APPLICABILITY: 2014MY Impreza
2015MY Forester, WRX and WRX STI Models

NUMBER: 05-59-15

SUBJECT: Change to Front Strut Mounting Nuts

PART INFORMATION:

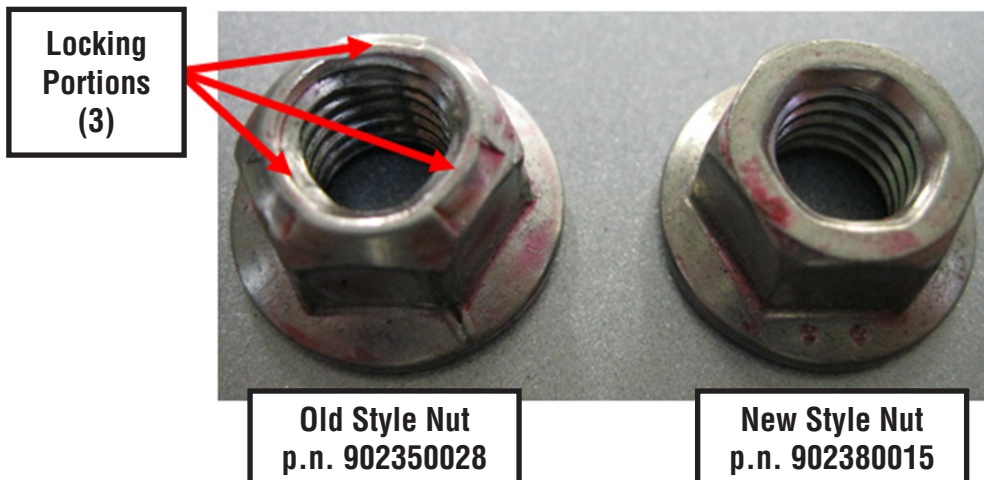
The Old Style flange nuts with 3 “locking portions” have been replaced by the New Style “smooth” nuts..

NOTE: The nuts are interchangeable between new and old but it is recommended to use all of one style or the other to maintain uniformity. The torque specification is unchanged (14.8 ft. lbs.).
